From: WILLIFORD Dennis (AREVA) [Dennis.Williford@areva.com]
Sent: Monday, May 06, 2013 2:17 PM
To: Snyder, Amy
Cc: Miernicki, Michael; ANDERSON Katherine (EXTERNAL AREVA); DELANO Karen (AREVA); HONMA George (EXTERNAL AREVA); LEIGHLITER John (AREVA); LEWIS Ray (EXTERNAL AREVA); ROMINE Judy (AREVA); RYAN Tom (AREVA); VANCE Brian (AREVA); ABAYAN Victor (AREVA); SHEPHERD Tracey (AREVA); LOSEKE Brian (AREVA); ALCHAAR Nawar (AREVA); CORNELL Veronica (EXTERNAL AREVA)
Subject: Advanced Response to U.S. EPR Design Certification Application RAI No. 371, FSAR Ch. 3, Question 03.07.01-29
Attachments: RAI 371 Advanced Response Question 3.7.1-29 - US EPR DC.pdf

Attached is an Advanced Response to RAI No.371, Question 03.07.01-29 in advance of the final response date of June 20, 2013.

From: WILLIFORD Dennis (RS/NB)
Sent: Monday, May 06, 2013 1:50 PM
To: Amy.Snyder@nrc.gov
Cc: Michael.Miernicki@nrc.gov; ANDERSON Katherine (External AREVA NP INC.); DELANO Karen (RS/NB); LEIGHLITER John (RS/NB); ROMINE Judy (RS/NB); RYAN Tom (RS/NB)
Subject: Response to U.S. EPR Design Certification Application RAI No. 371, FSAR Ch. 3, Supplement 28

Figure 03.07.01-29-1—Comparison of Alpha-Beta / RG 1.61 Damping – HELB/Seismic

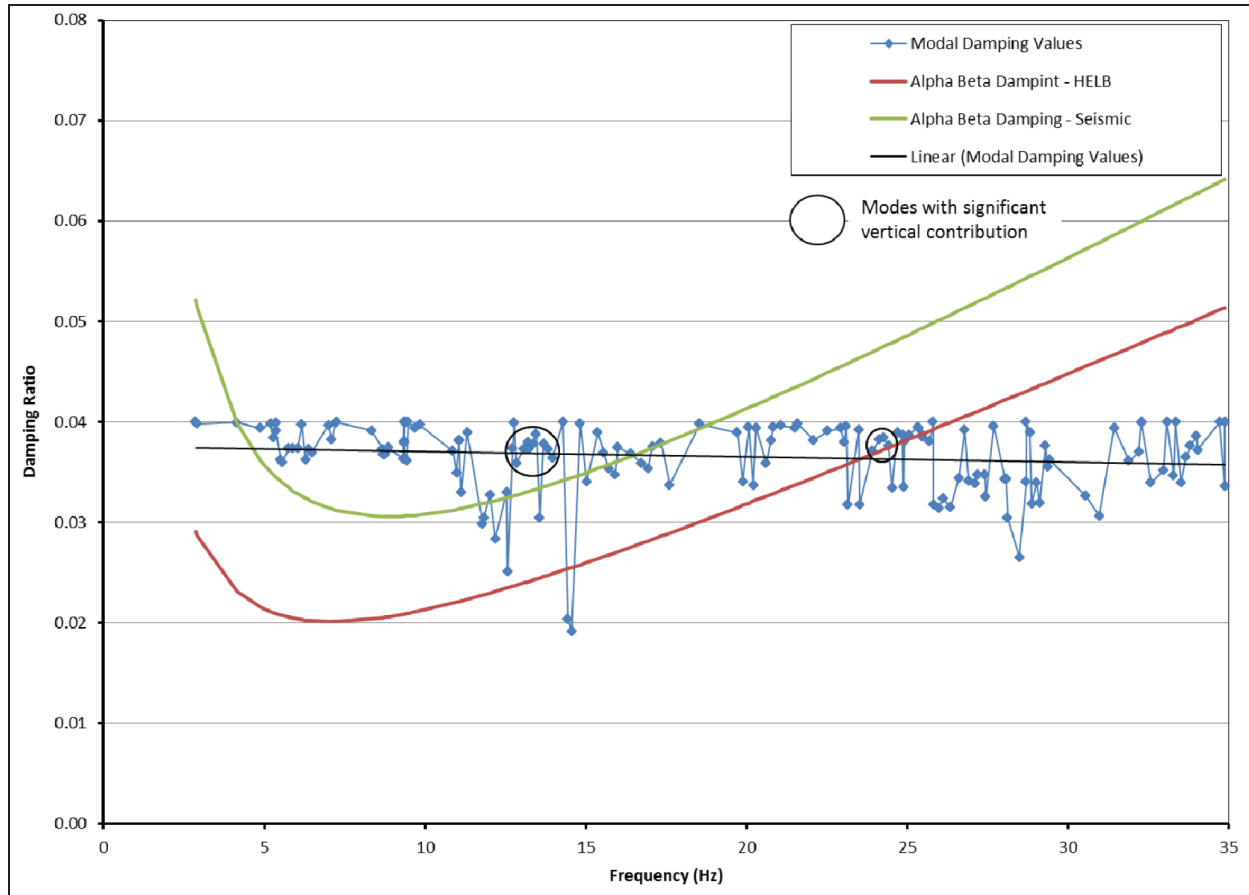
The applicant has provided a comparison between modal damping using RG 1.61 and Rayleigh damping using assumed values for alpha and beta. The alpha and beta values used to develop the Rayleigh damping curve in Figure 3.7.1-22-1 are 0.9 and 0.00045, respectively. According to Appendix 3C.4.2.1.1 of the U.S. EPR FSAR these values are not the values used for seismic analysis as was requested by staff but are the values used for the RCS four-loop high energy line break analysis. In Appendix 3C.4.2.2 a different set of values of alpha and beta are given for the RCS seismic analysis. These values are 1.7 for alpha and .00055 for beta. As such there is inconsistency between the applicant's response to RAI 03.07.01-22 and the FSAR Appendix 3C.4.2.1.1. Use of higher values of alpha and beta can result in damping values that may not be conservative.

Figure 03.07.01-29-1 compares the alpha-beta damping used for HELB and seismic analyses with the RG 1.61. The RG 1.61 damping values have been modified due to the changes in Internal Concrete Structure damping to OBE levels as discussed in RAI 370, Question 03.07.01-27. This change has reduced the RG 1.61 damping used in the RCS analysis. The Rayleigh damping values for the HELB structural analysis remain conservative for the RCS frequencies of interest.

The linear regression trend in Figure 03.07.01-29-1 represents a curve fit for the applied modal damping values. Figure 03.07.01-29-1, shows that the seismic alpha-beta damping curve falls below the curve fit up to 16 Hz. As previously explained, more than 94 percent of the lateral effective mass of the RCS components is accounted for below a frequency of 16 Hz and crosses the 0.04 damping ratio line at approximately 19 Hz. The alpha-beta curve for HELB analysis intersects the linear regression curve fit at about 23 Hz and crosses the 0.04 damping ratio line at approximately 26 Hz, indicating that majority of the RCS effective mass in all directions is damped below the modal damping allowed by RG 1.61; and, therefore, remains conservative.

U.S. EPR FSAR Tier 2, Figure 3C-9 will be revised as described in the response and as indicated on the enclosed markup.
